**DOCUMENT 00 90 00
ADDENDUM**

ADDENDUM NO. [2] Date: October 10, 2019

**RE: LANESBORO PUBLIC SCHOOLS
 ADDITION AND REMODEL REBID
 100 KIRKWOOD ST EAST
 LANESBORO, MN 55949
 HSR 18063**

**FROM: HSR Associates, Inc
 100 Milwaukee Street
 La Crosse, WI 54603
 (608) 784-1830**

A307

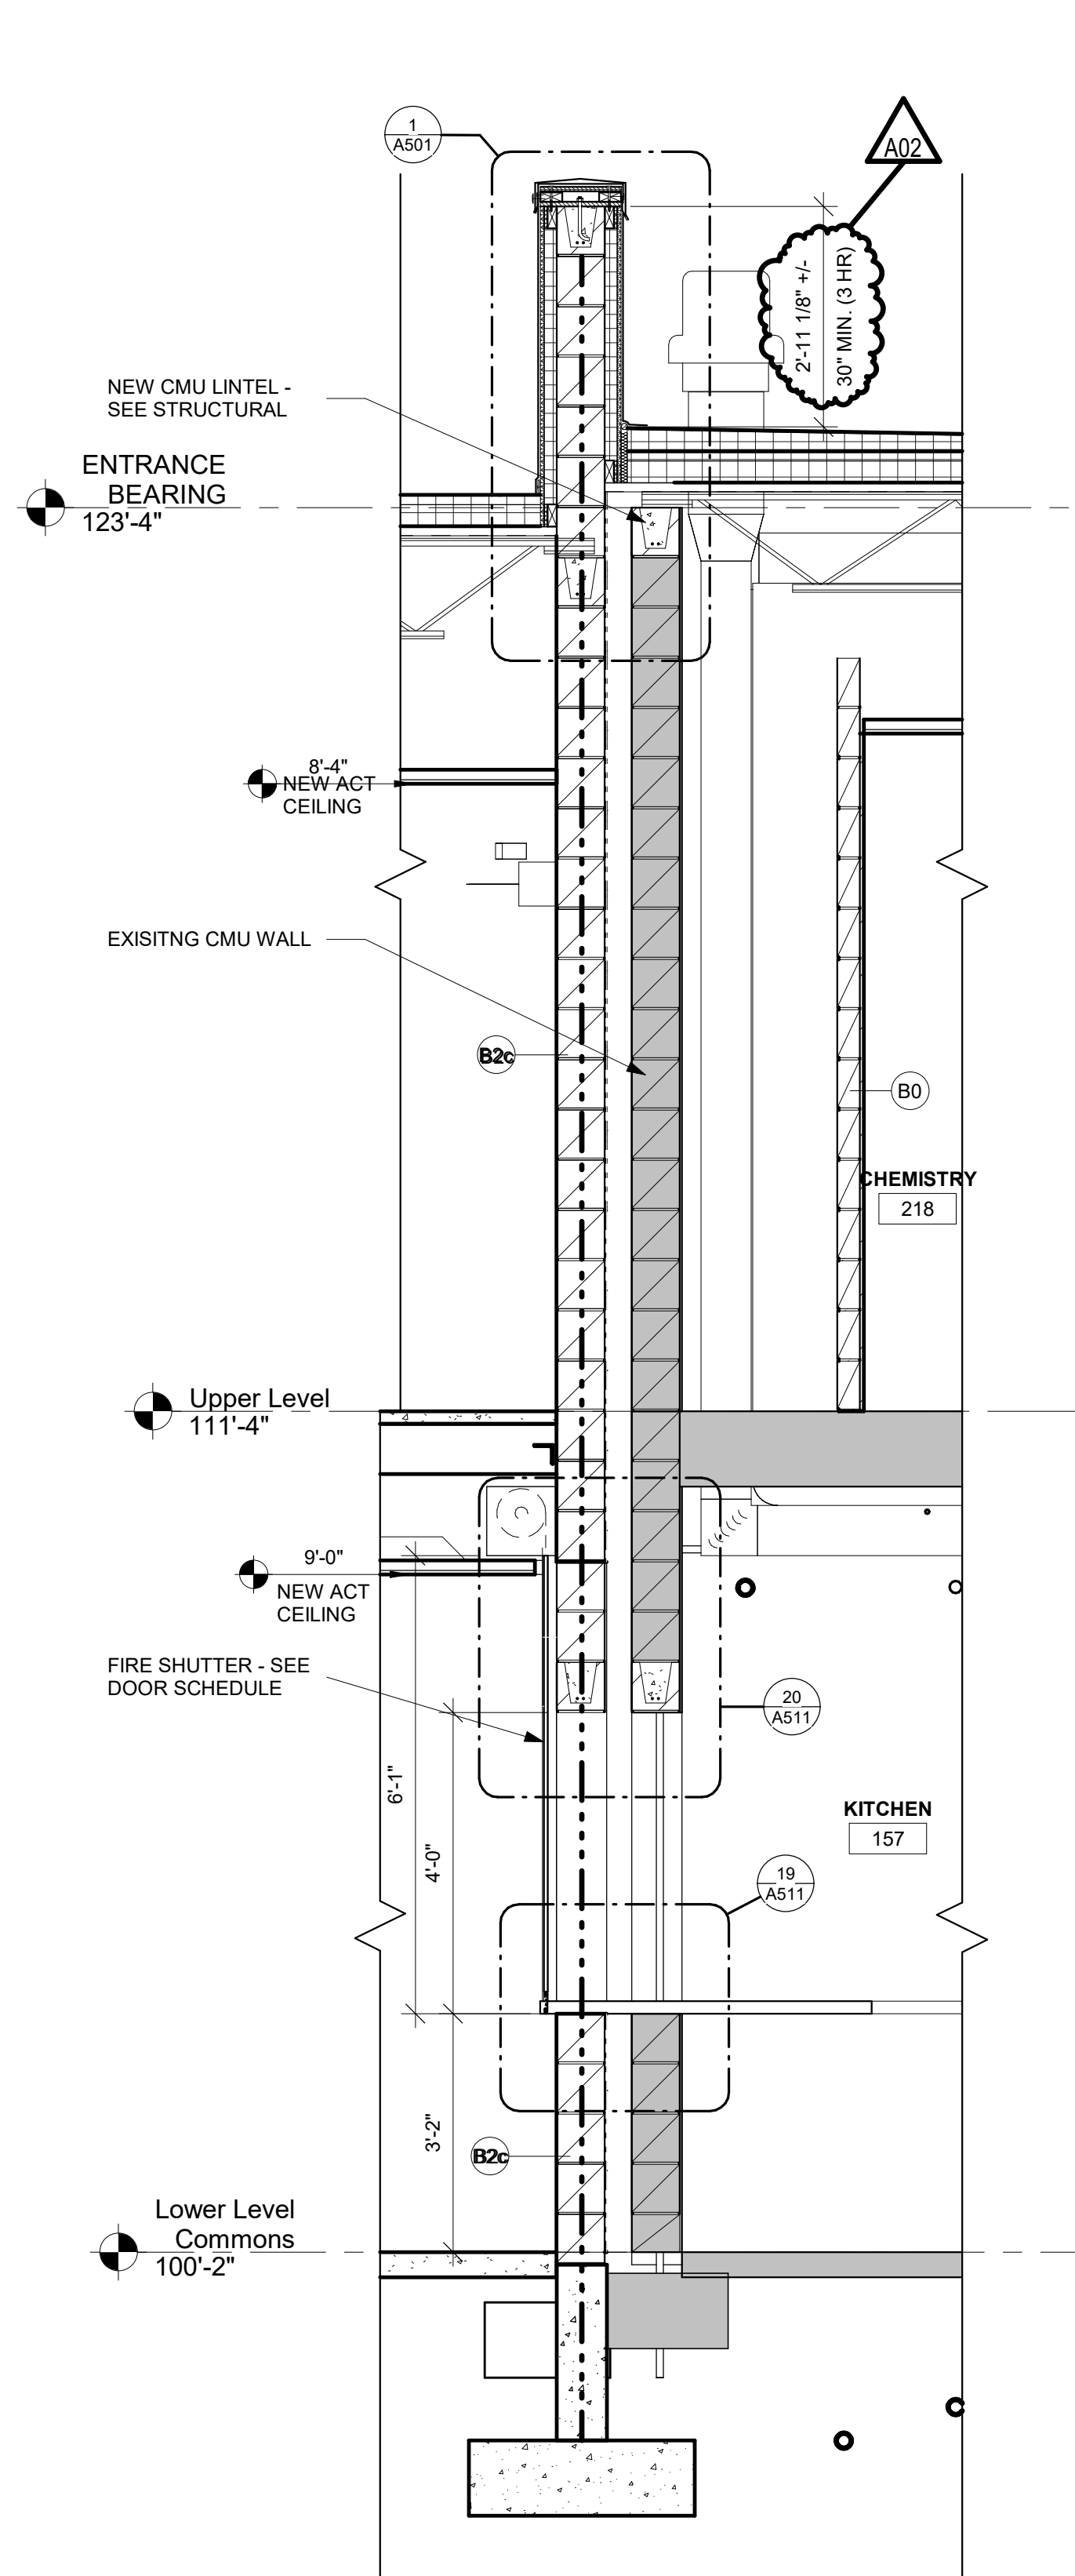
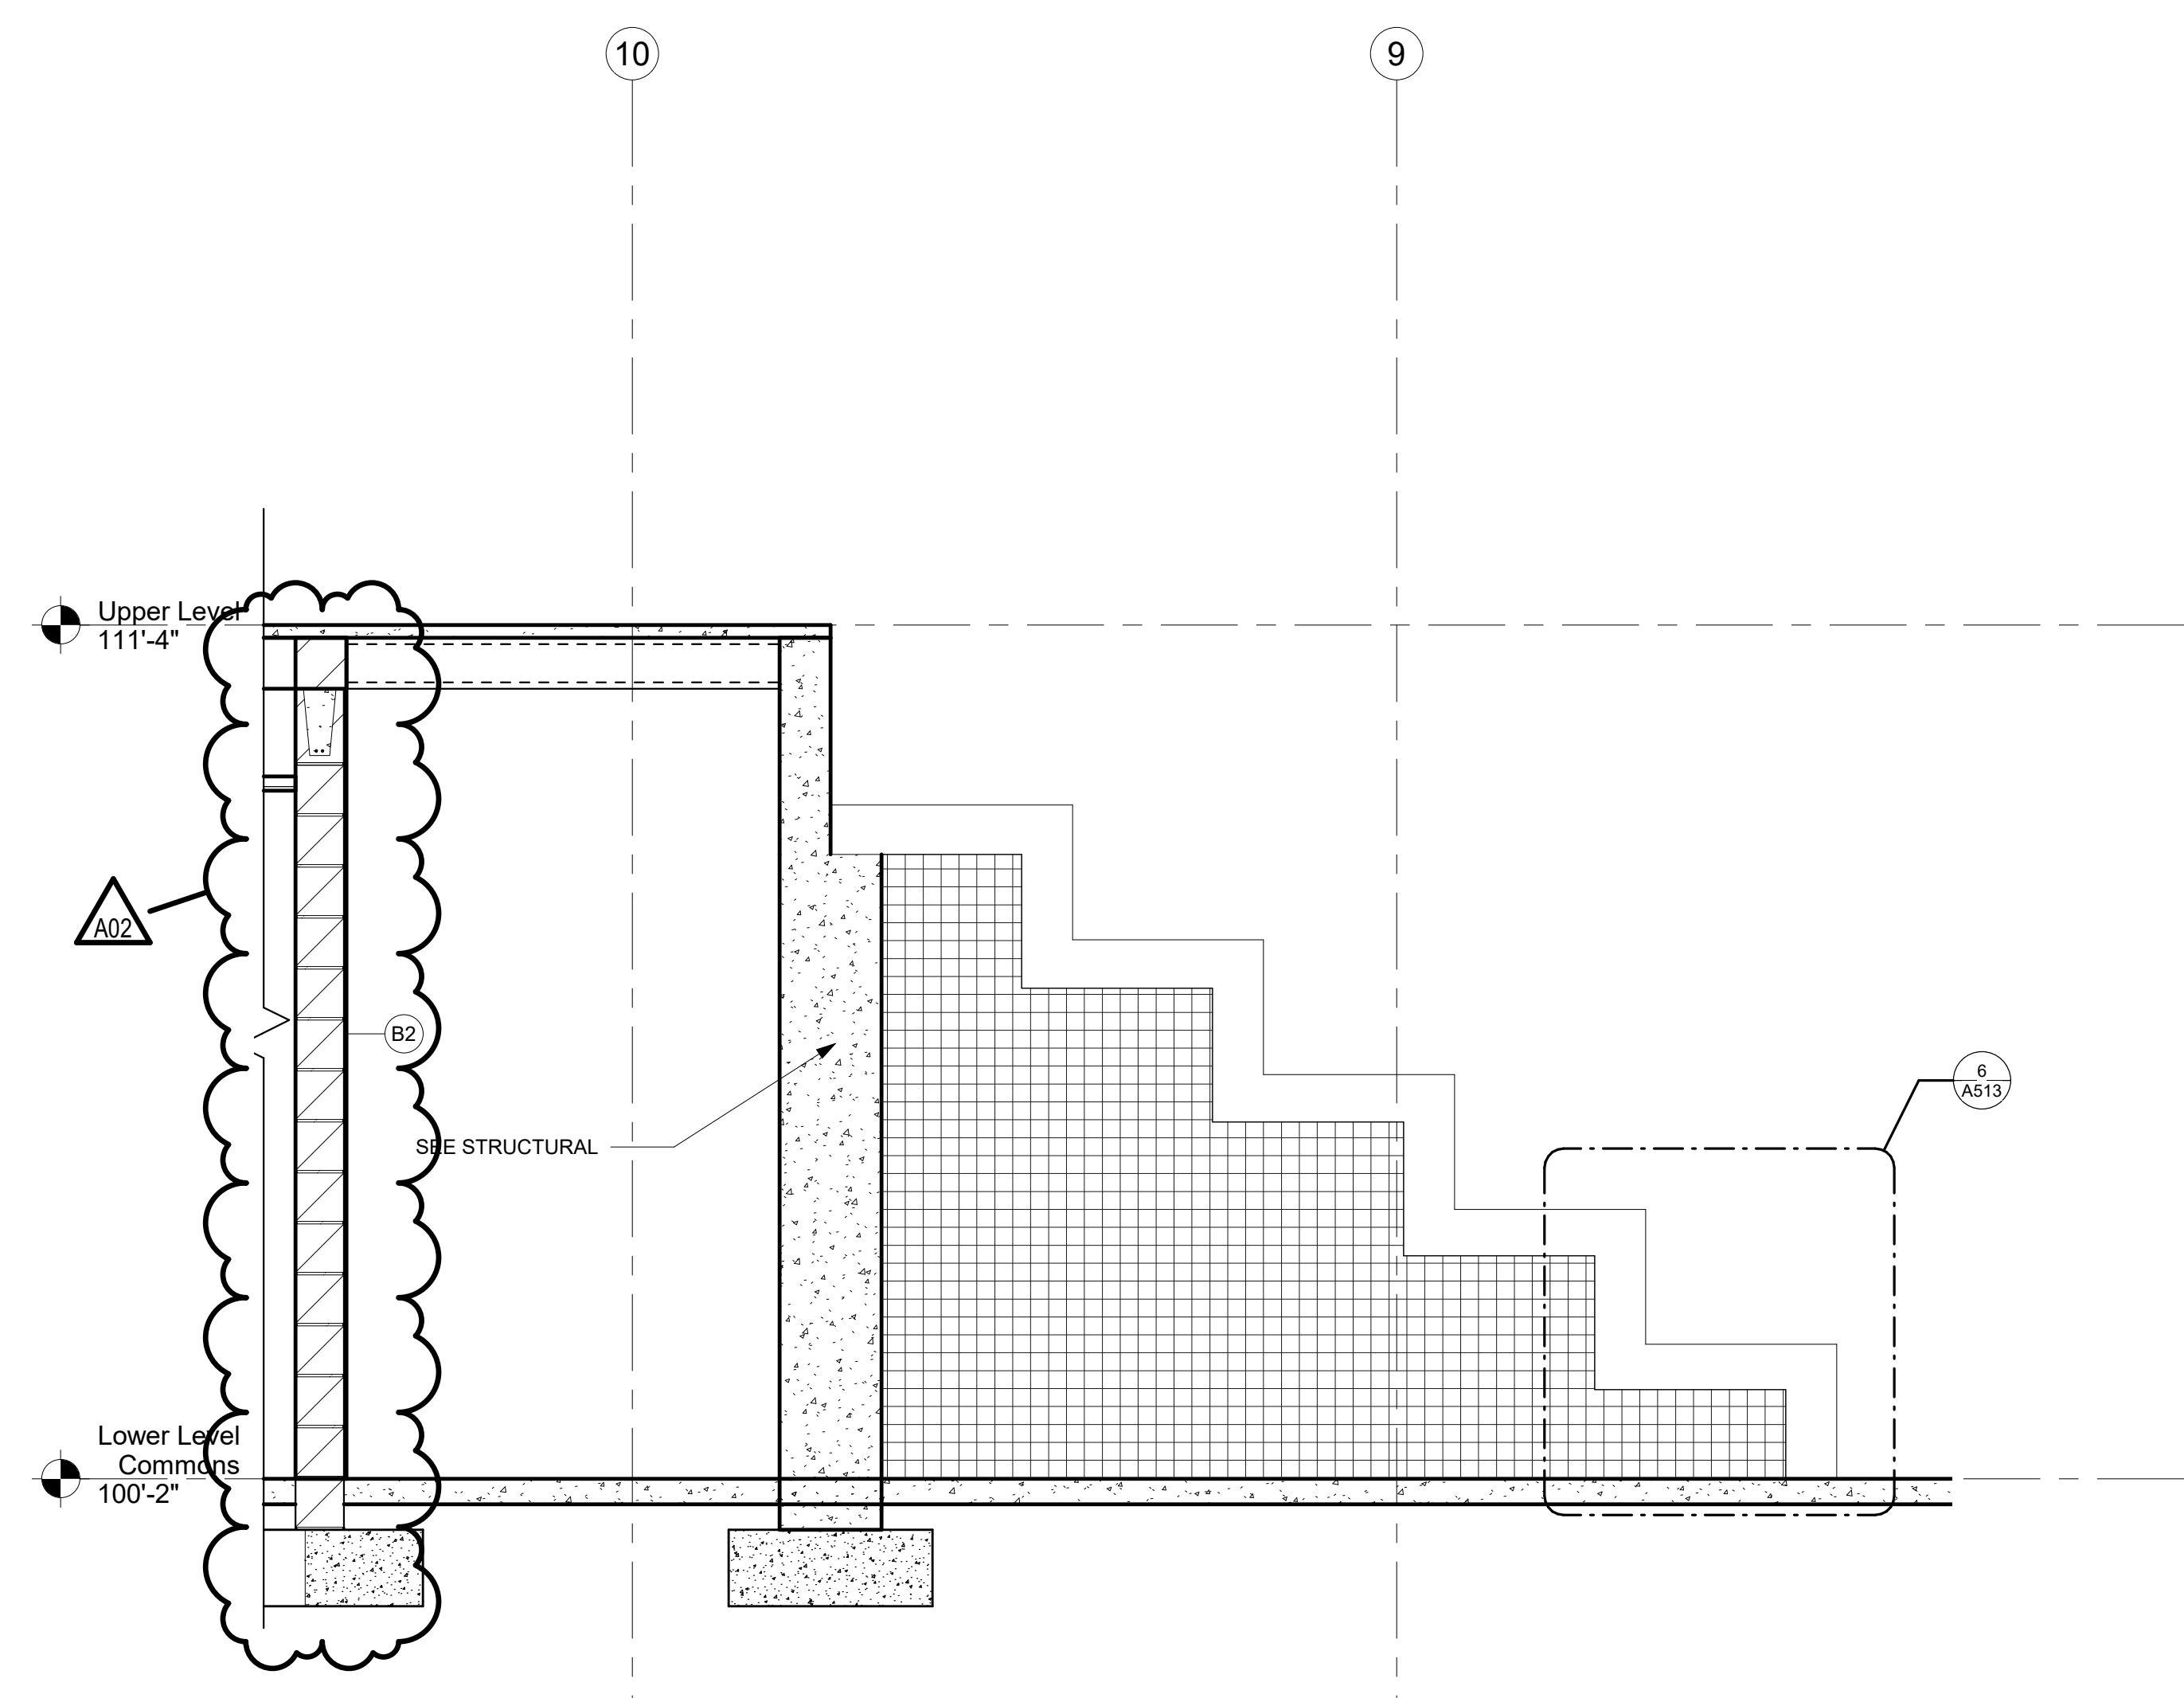
33. Sheet A307 WALL SECTIONS 30 x 42 attached hereto
 - a. Revisions clouded on Drawing.
 - b. Code required extension of 3 hour wall indicated at 1A307
 - c. 3A307: Wall rating removed from CMU wall at left side of detail.

A308

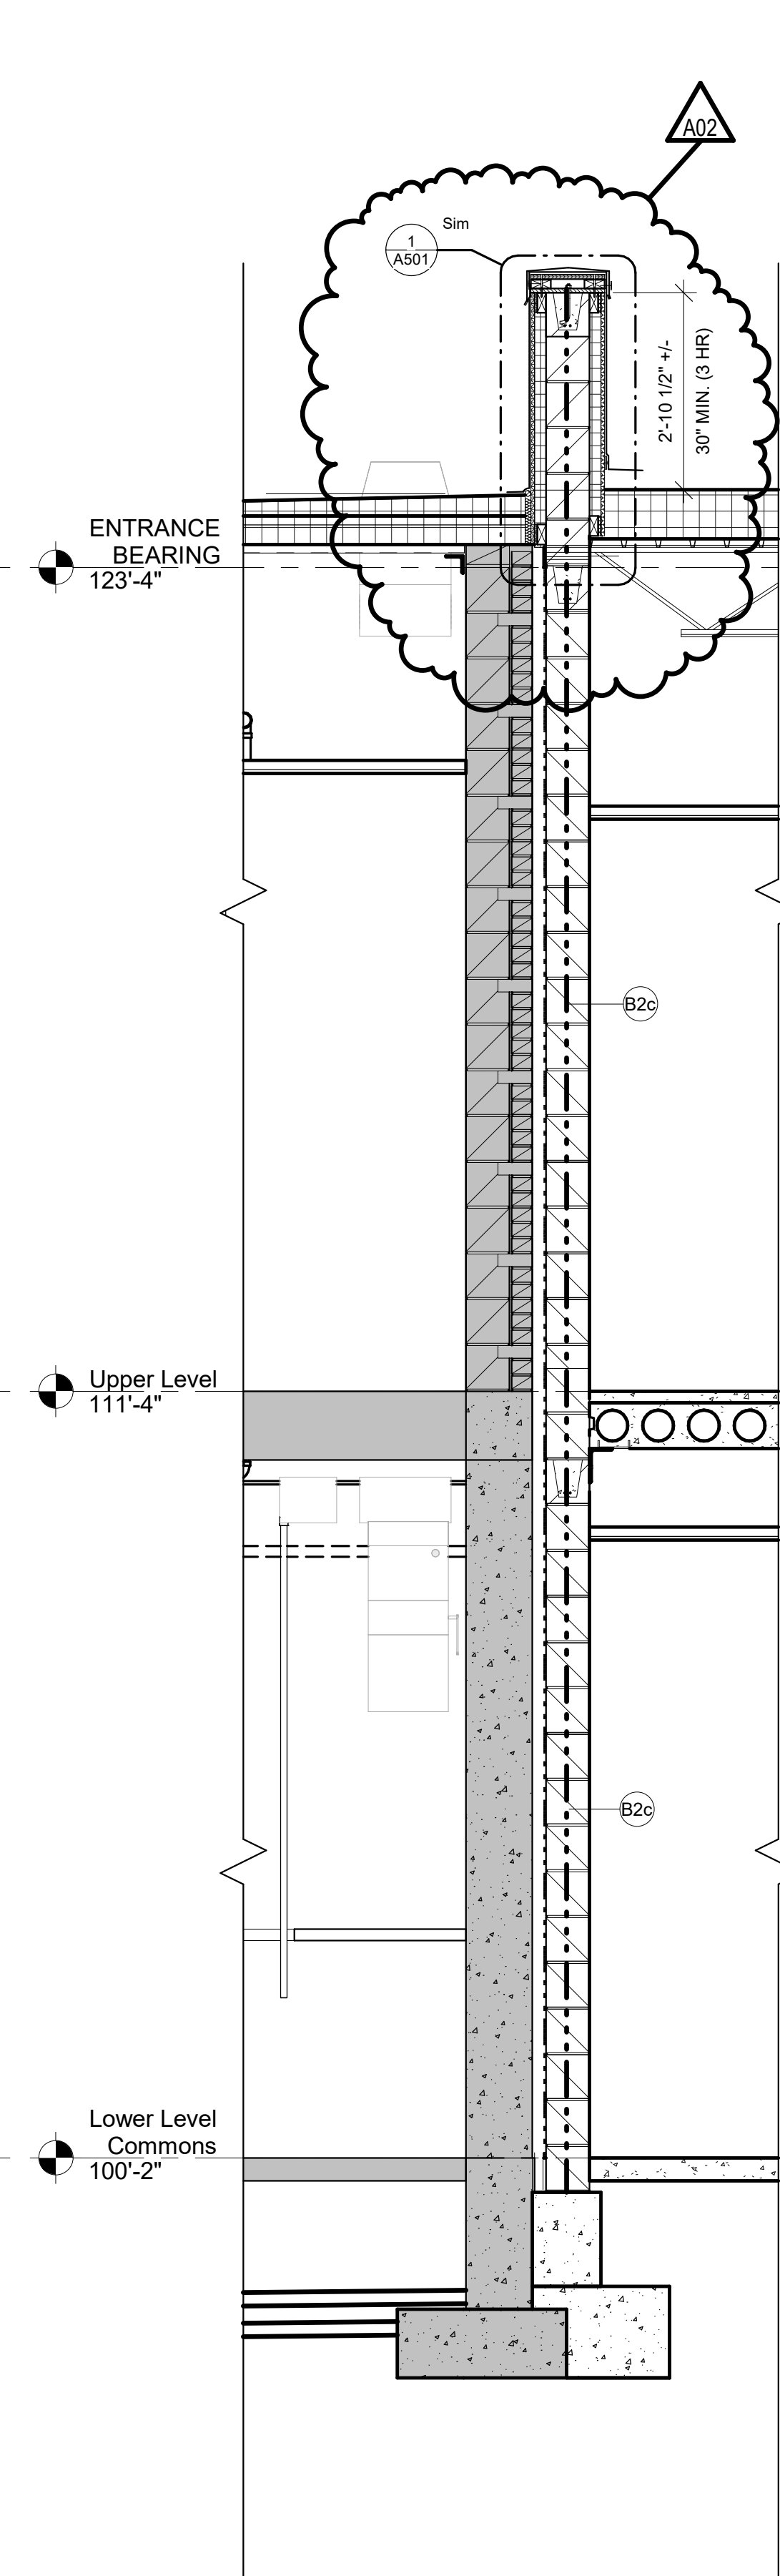
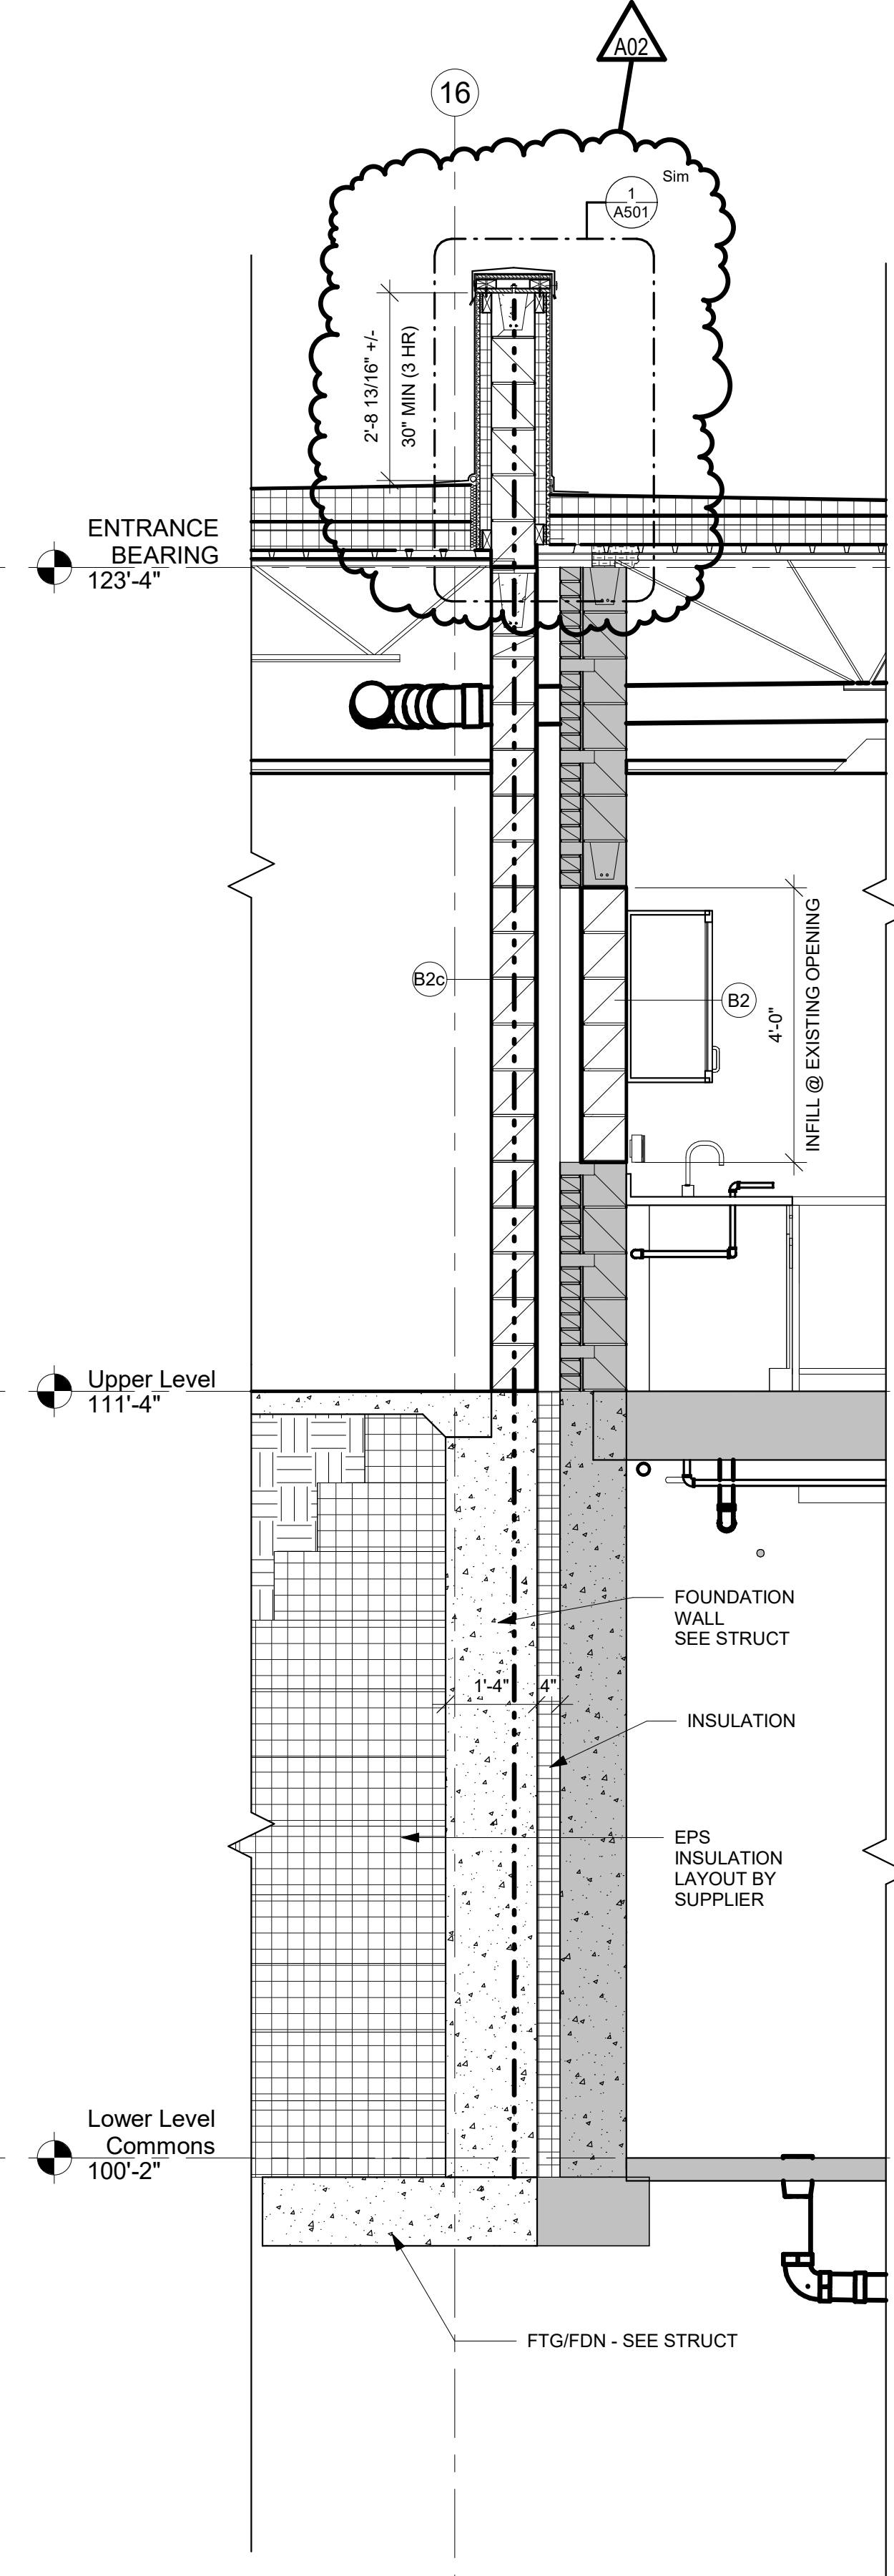
34. Sheet A308 WALL SECTIONS 30 x 42 attached hereto
 - a. Revisions clouded on Drawing.
 - b. Code required extension of 3 hour wall indicated at 2 and 3A308.
